Access Compliance Report

Public Rights-of-Way

(Curb Ramps)

Intersection ID: 10025537	Main Street: E_STONEWALL_ST	Cross Street: N/A	Location: SE
ADA ID: 5DA04DAEA013	Ramp Type: PerpDiag	Initial Pass/Fail: Pass	Overall Compliance: No
		Severity Score: 7.5

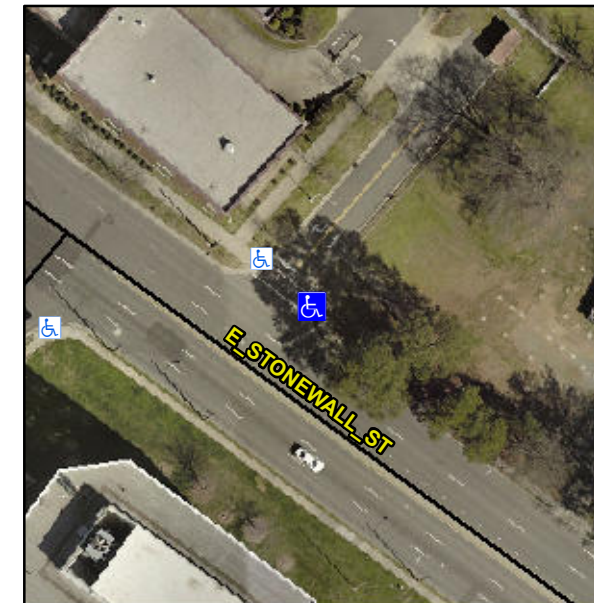
Not Found, R305.2, R302.7.2

Remove & Replace Curb Ramp With Two New Directional Ramps or Equivalent.
